Interactive comment on “Ground-penetrating radar insight into a coastal aquifer: the freshwater lens of Borkum Island” by J. Igel et al.

J. Igel et al.

We would like to thank the reviewer for the thorough review that will help to improve the manuscript.

Fig. 1. Uncorrected groundwater tables deduced from GPR (lines) and water tables in the observation wells (diamonds).

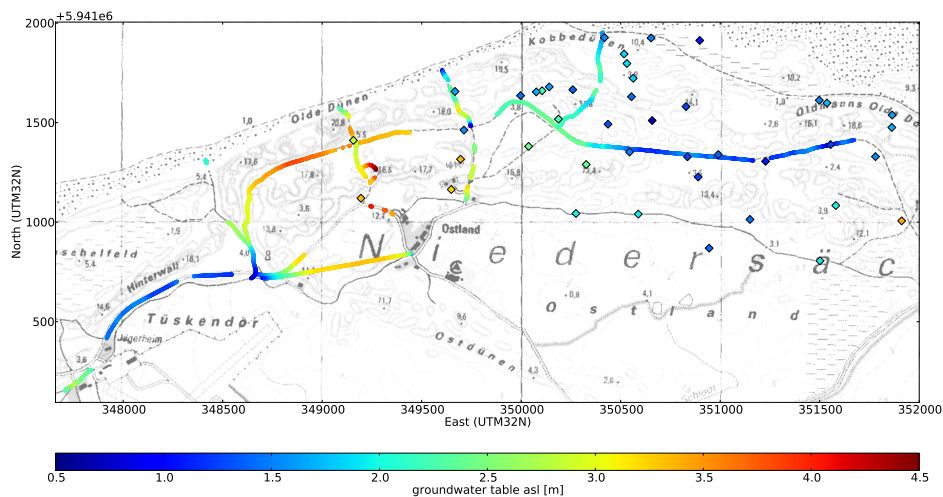
RC3) *I have very some reservations regarding the discussion of the large deviations between groundwater table depths measured in the wells and those determined from*
C5325

AC3) We re-analysed the relation of GWT from observation wells and from GPR and will revise this section in the manuscript. We now only use observation well readings carried out at the same time the GPR measurements were done (at maximal 14 days after the GPR measurements). There is only a minor effect of temporal changes in the GWT remaining (changes of GWT from observation wells in this area are at maximum 5–10 cm/month). Furthermore, only wells with their filter in the upper aquifer were taken into consideration. Figure 2 (supplementary material) shows a cross-plot of pressure heads of wells closer than 25 m to GPR lines and uncorrected GPR groundwater tables. GPR shows systematically higher water tables than the pressure heads in the wells. Causes for this shift are:

Fig. 2. Uncorrected GPR groundwater tables vs. pressure heads of wells closer than 25 m to GPR lines. The solid line shows a regression that crosses the y-axis at 45 cm.

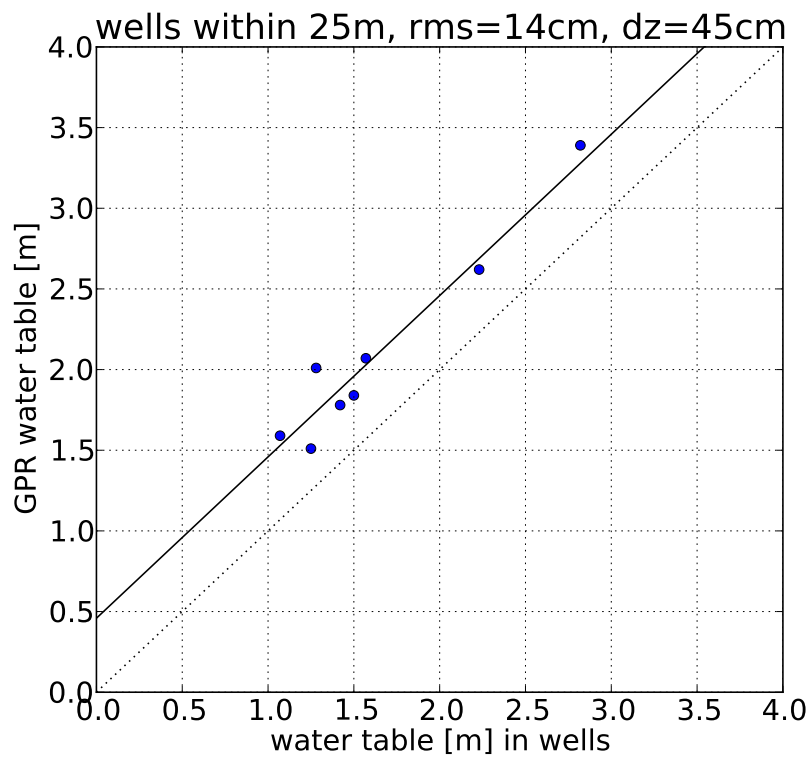
the GPR measurements as presented in Sect 4.3. Overall, an RMS error of 50 cm with observation wells closer than 30 m to the GPR line is unacceptable. This clearly puts the applicability of GPR-measured groundwater tables for modelling studies into question, which would be unfortunate. In this study, the various error sources listed by the authors require further investigation and especially interpretation (e.g. by merging with other geological information about the spatial distribution of the confining layers, time series of data showing the temporal groundwater dynamics, data from other geophysical investigations conducted within the project, ...) in order to be able to reduce the measurement error. Especially groundwater table depths determined by GPR measurements cannot be compared to pressure heads of a confined aquifer as the authors state correctly. These areas would have to be removed from the comparison but still could contribute to the discussion of the hydraulic situation. Here I strongly encourage the authors to carefully revise this section before publishing the paper.

- Inaccuracies of the velocity model that is used to transform traveltimes into depths.

- Time-zero correction of the GPR data and systematic errors in picking the reflections.
- Capillary fringe: GPR reflections are caused by changes of dielectric permittivity as a function of water content. Therefore GPR (and every geophysical technique) yields a higher water table than the pressure head in wells, as already explained in the manuscript. We assessed the capillary fringe by a simple experiment to be 13.5 cm (see manuscript). However, the porosity of the sand was 42% for the lab experiment compared to 36% in the field so that the capillary rise height must be larger in situ. Additionally, the reflection point at the GWT depends on the transition zone above and the shape of the GPR signal. A detailed analysis of this relation would go beyond the scope of this paper and would need additional information that is not available and still subject to research.

Therefore, we decided to use the information from the wells for calibrating the GPR water tables and included a figure (Fig. 2 in this reply). Regression shows that a shift of GPR water tables by 45 cm (solid line), minimizes the RMS deviation between wells and GPR from 50 cm to 14 cm. The shift includes all effects mentioned above of which the capillary rise is probably the most important.
